TO: John Sponseller
FROM: Carson Byerhof, Planner I
DATE: July 28, 2022
SUBJECT: SP22-041 – Dunkin Donuts
Review Comments 01

**SITE PLAN FOR
DUNKIN' DONUTS
DOUGLAS 234, FILING NO. 6,
AMENDMENT 1, LOT 4**

NORTH ELEVATION (DRIVE THRU)

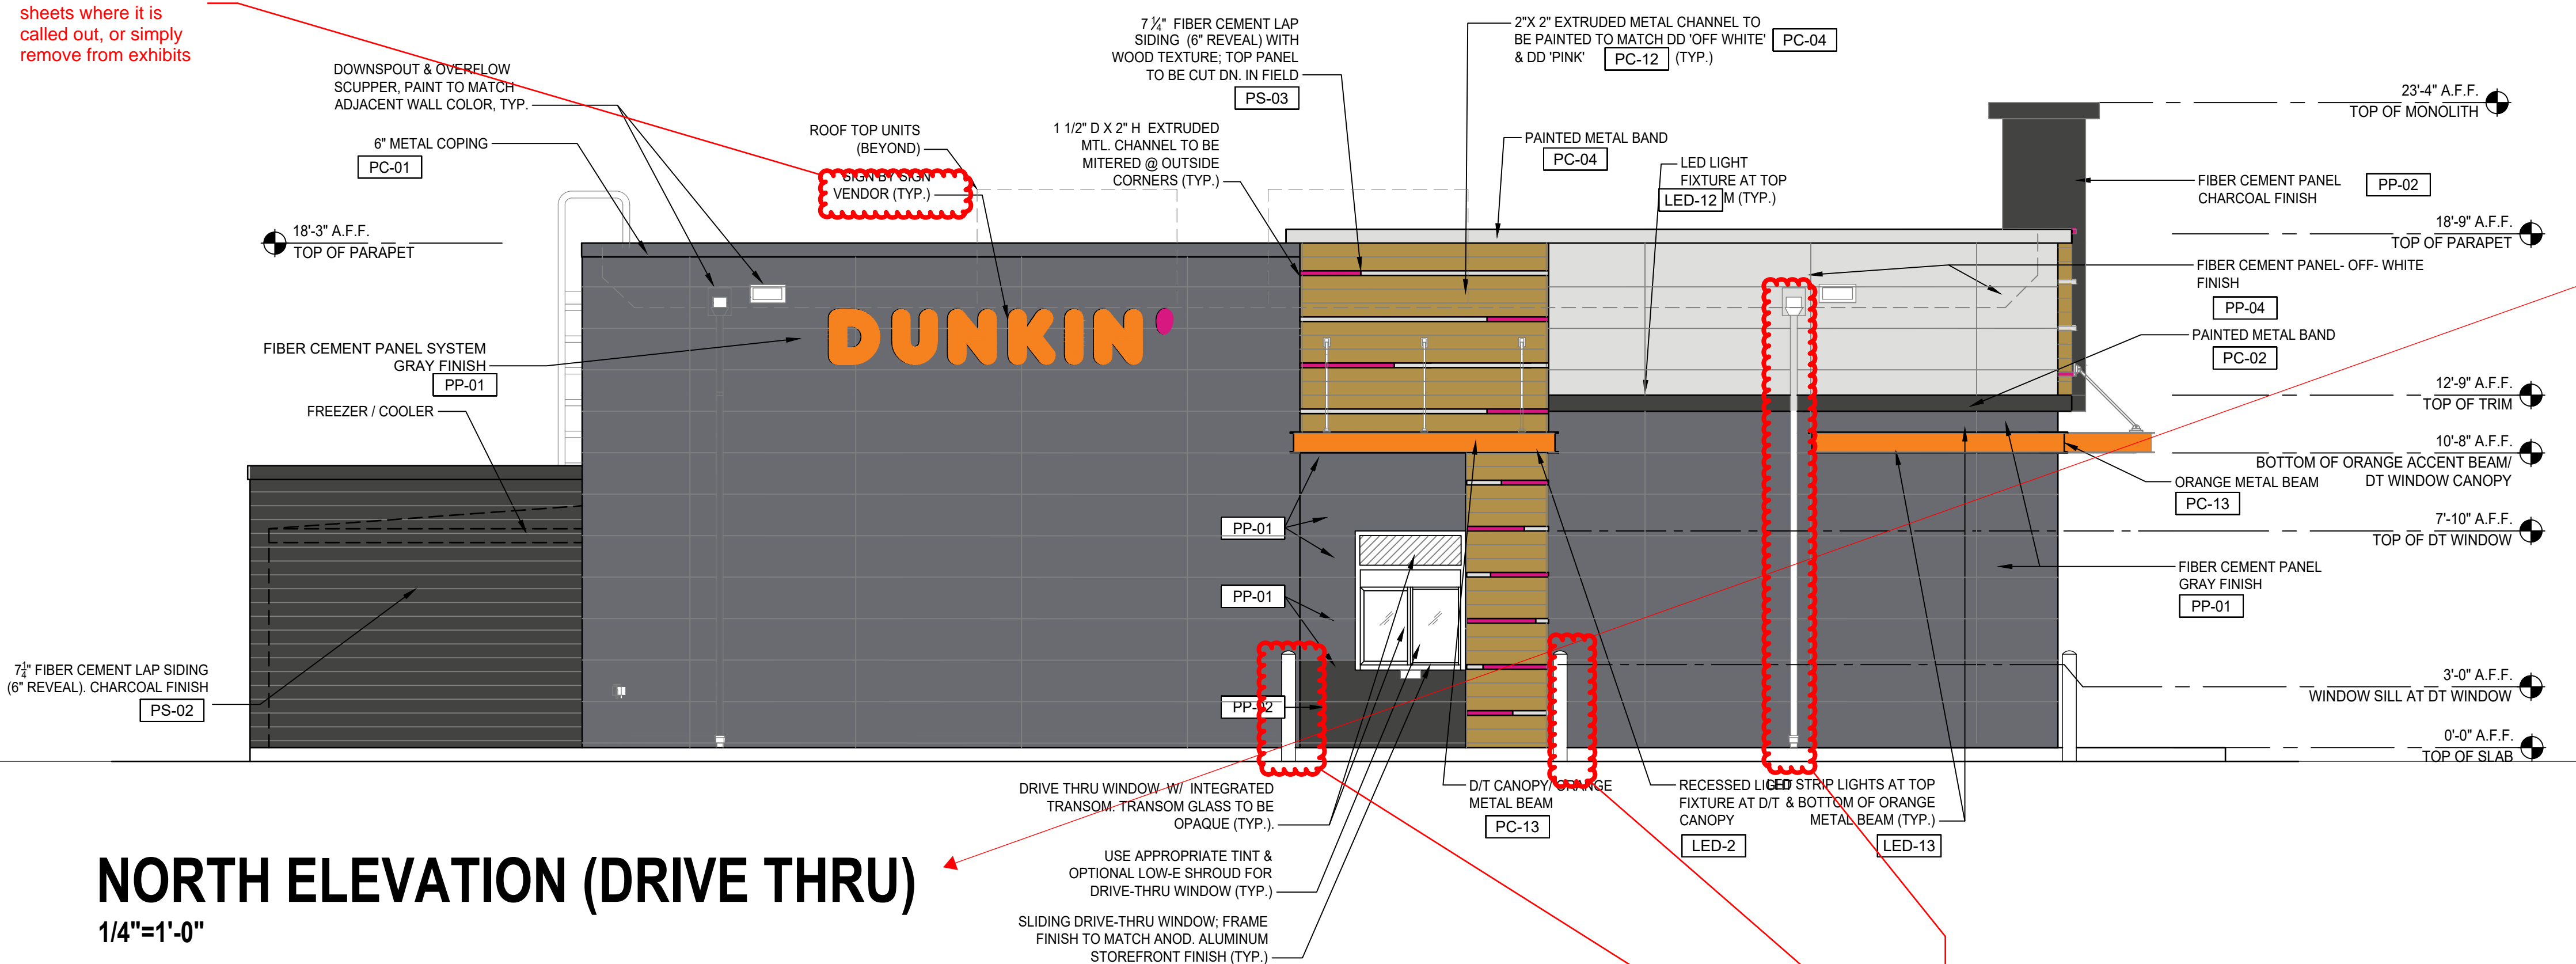
Considered front by design standards. Needs to meet transparency requirement of 40% if less than 100' or 30% if greater than 100'. Can add architectural features such as vertical slats, materiality changes, murals, etc. to use in lieu of transparency requirements. Please work out with sketch plans with planning.

Provide color for auxiliary features. Should match or contrast with architecture of building

TRASH ENCLOSURE (FRONT)

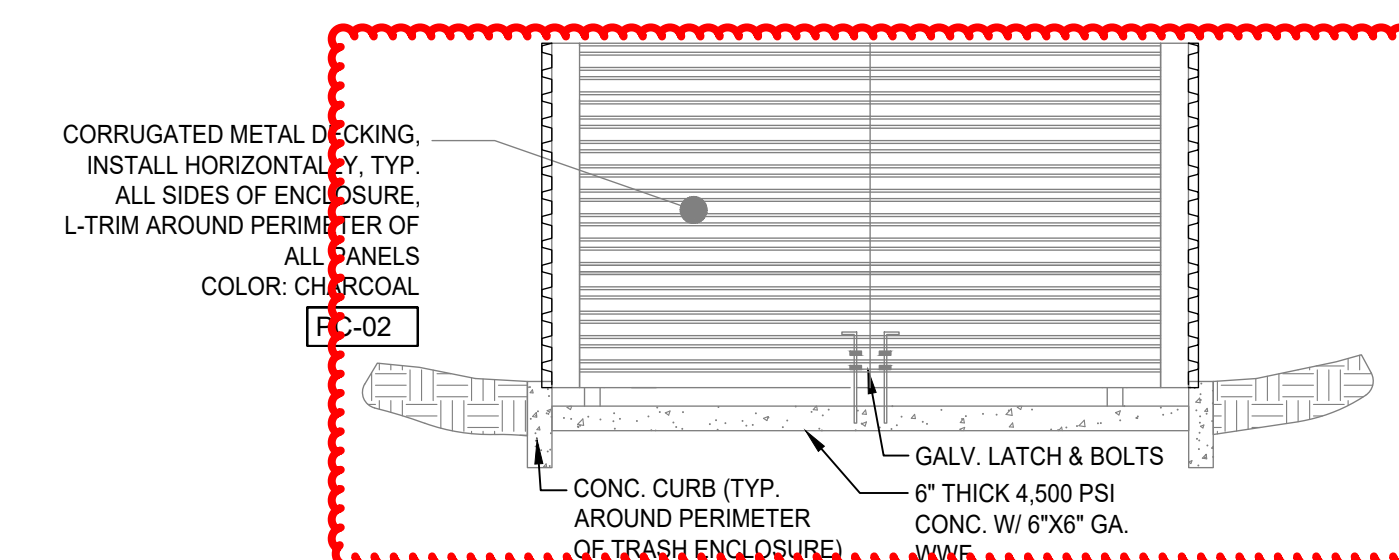
Considered side by design standards. Needs to meet transparency requirement of 25%. Can add architectural features such as vertical slats, materiality changes, murals, etc. to use in lieu of transparency requirements. Please work out with sketch plans with planning.

Provide color elevations for front and sides. Include material with materials board (should be of architectural material to match principal building)

WEST ELEVATION (PARKING/ CHAMBERS)
1/4"=1'-0"

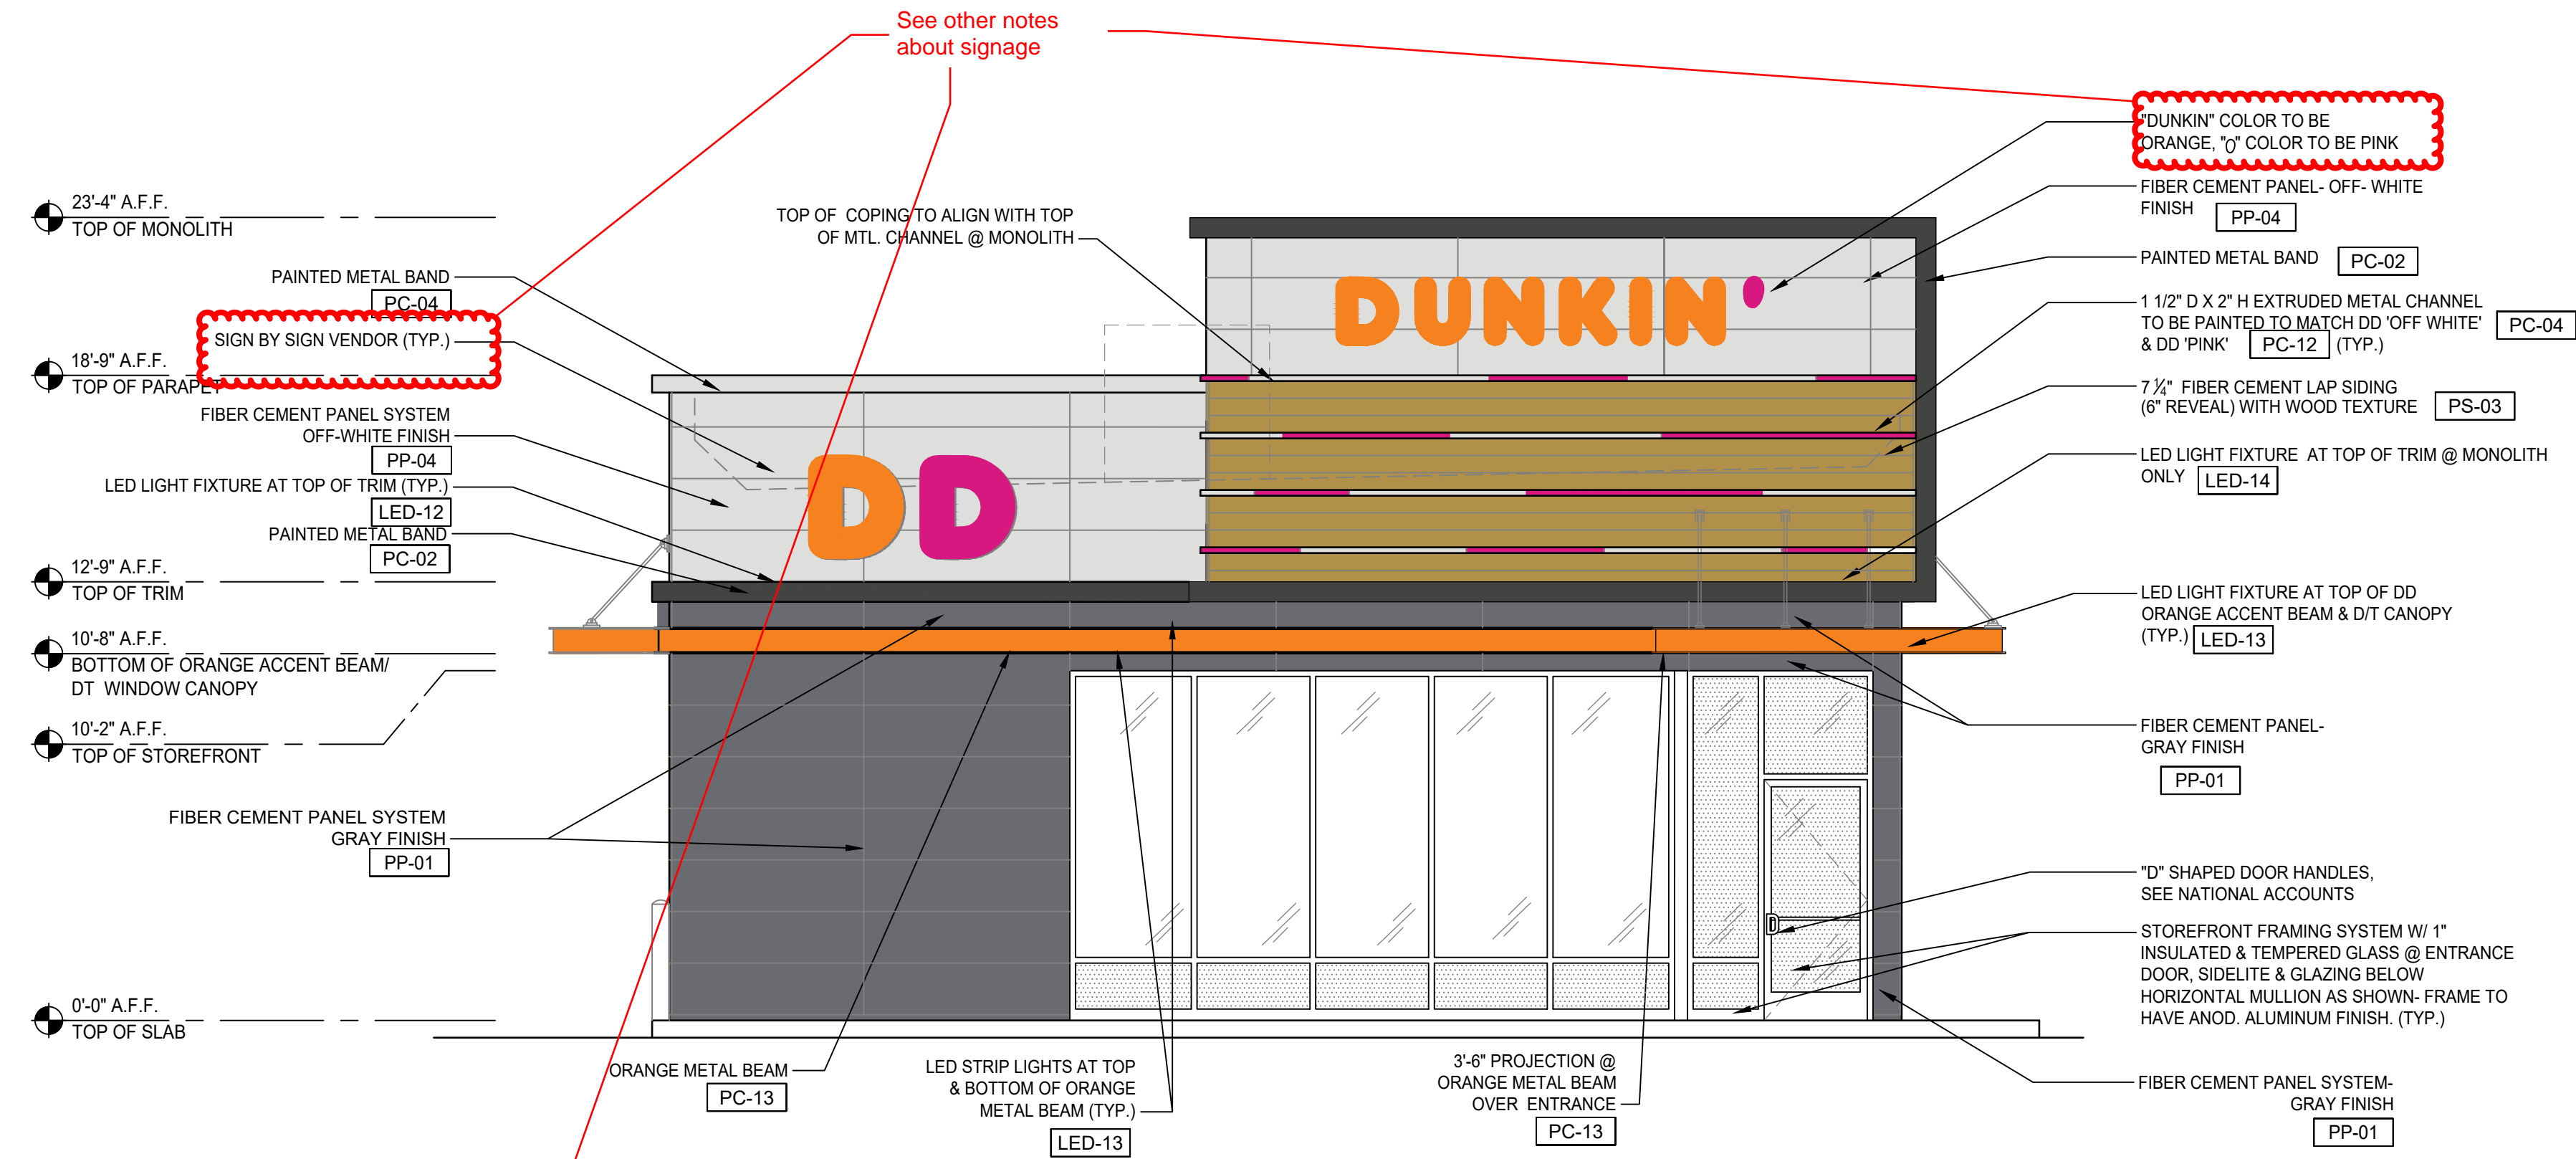
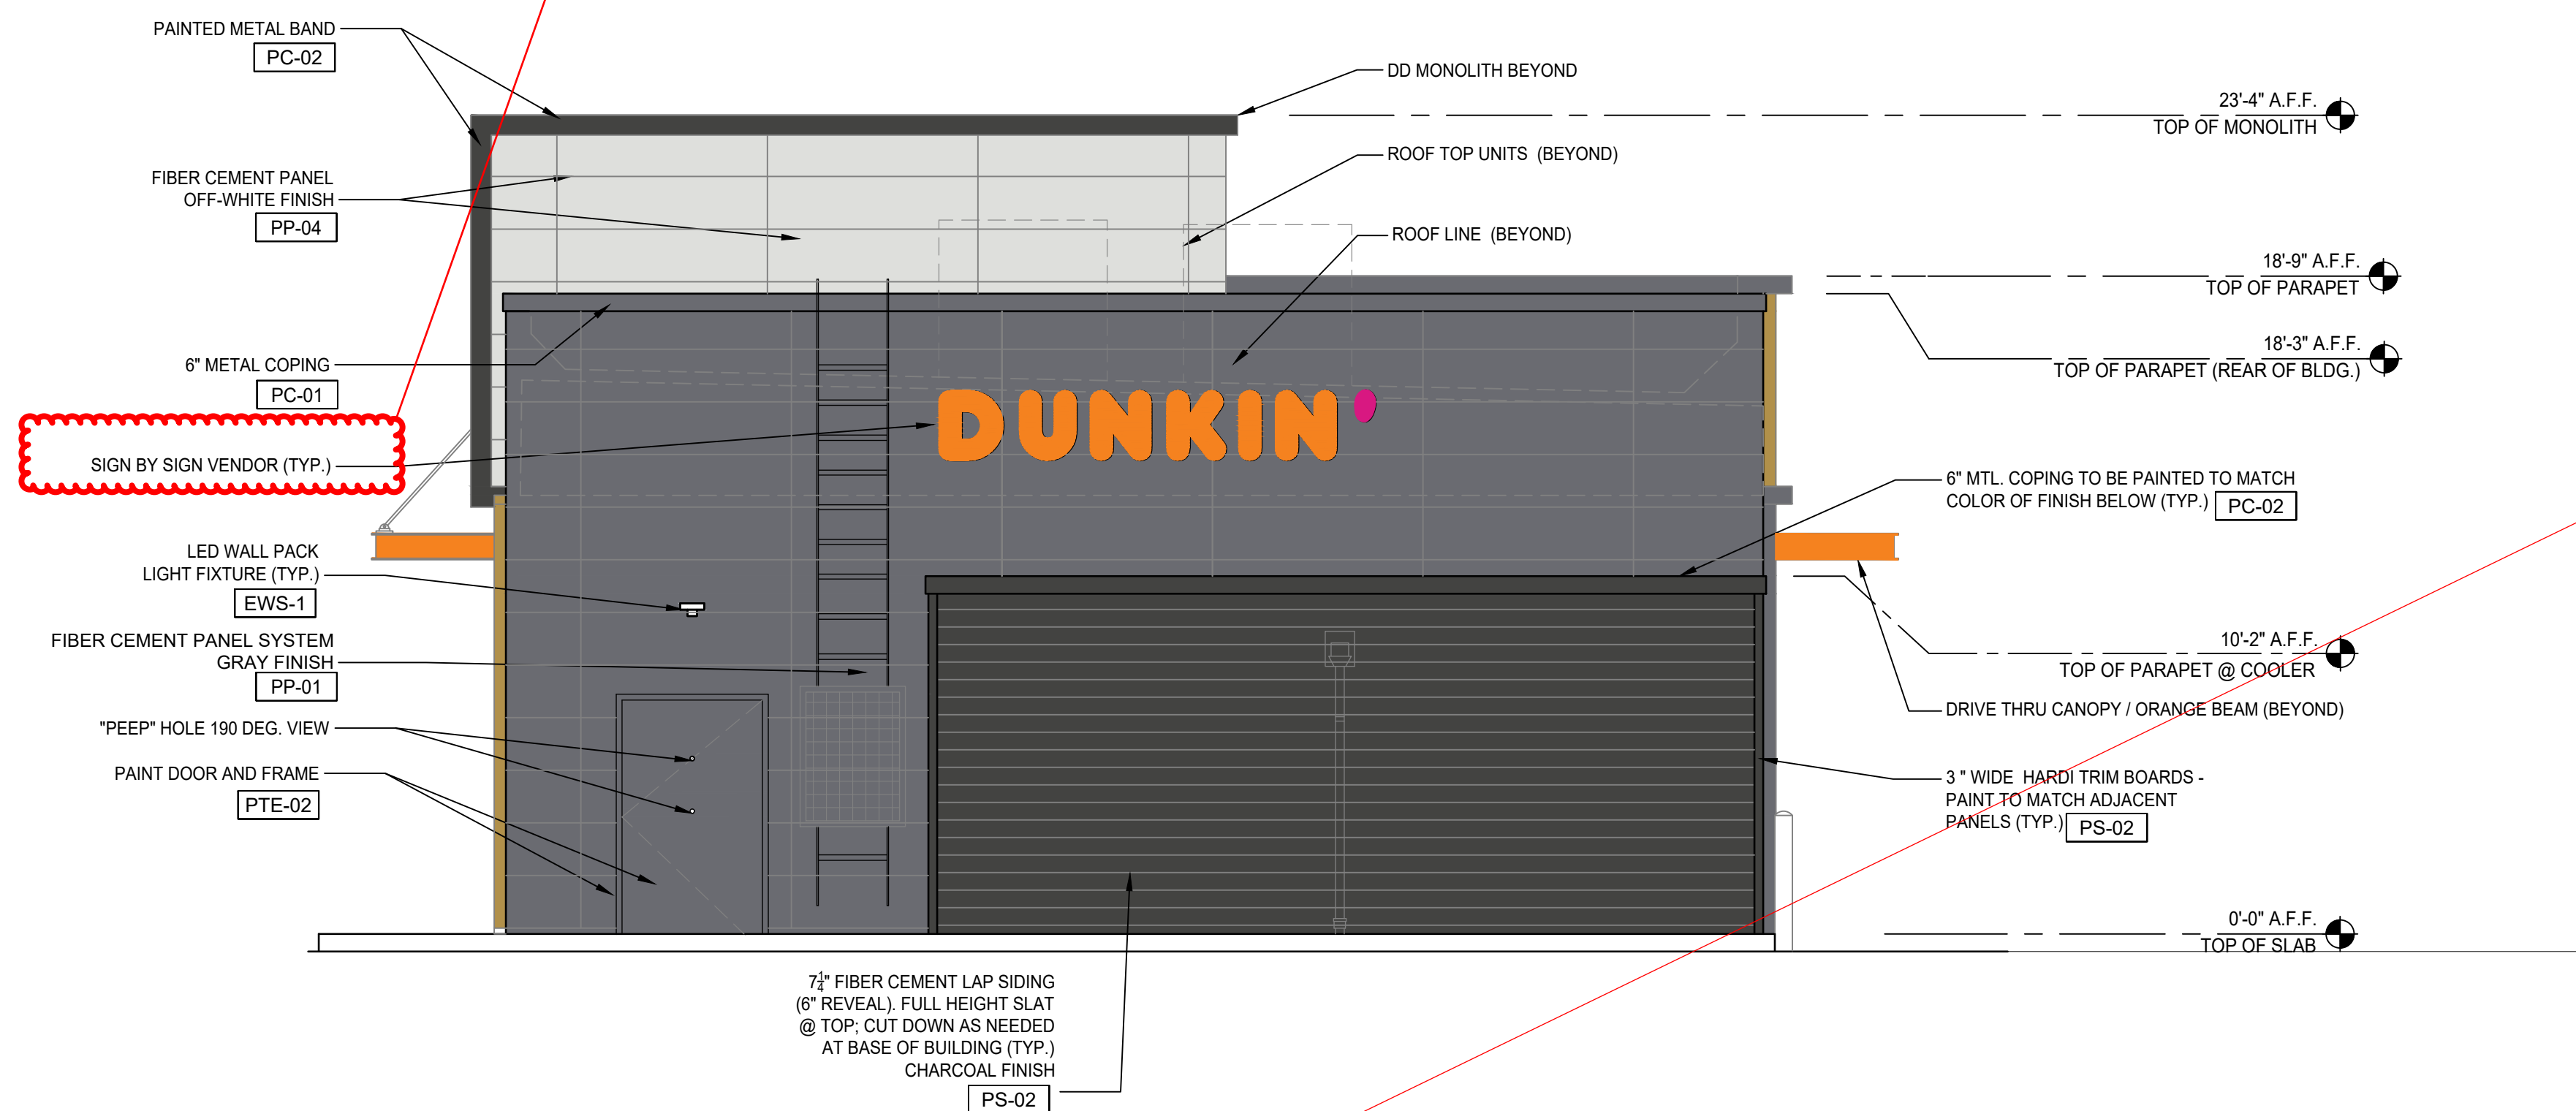
Considered front by design standards. Needs to meet transparency requirement of 40% if less than 100' or 30% if greater than 100'. Can add architectural features such as vertical slats, materiality changes, murals, etc. to use in lieu of transparency requirements. Please work out with sketch plans with planning.

NOTE: For the back, if transparency requirements cannot be met, please work with planning for alternatives to meet intent of street facing design standards
